TECHNICAL SERVICE BULLETIN

Technical Service Bulletin: 210-1321

Forest River is alerting you to an issue involving certain 2021 Coachmen Leprechaun Class C Motorhome recreational vehicles. Please see the information below, which describes the issue and provides you with details on the steps you should take to have your vehicle repaired.

The Auto Generator Start Control Panel Safety Option circuit is not properly grounded. The generator will not function/start as designed by auto-starting if the house batteries need charging.

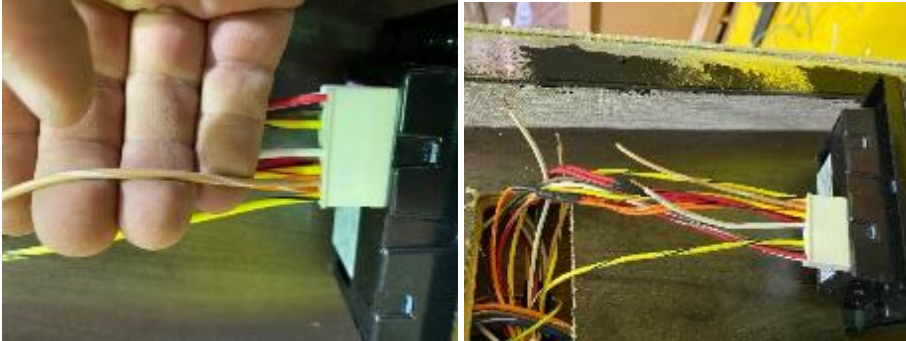
STEP 6: Locate the tan/white wire in position 15 on the connector and cut the wire 6-8 inches beyond connector.

STEP 7: Locate the white wire (ground) in position 13 of the connector and cut the wire approximately 6-8 inches beyond the connector.

STEP 8: Strip the casing on the white wires and the connector side of the tan/white wire back 1/2". Use the wire stripping guide on the side of the WAGO connector if necessary.

STEP 9: Insert the two white wire ends and the connector side of the tan/white wire into the 3-position WAGO connector. Set the clamp levers down in place tightly. Tape off the harness side of the tan/white wire.
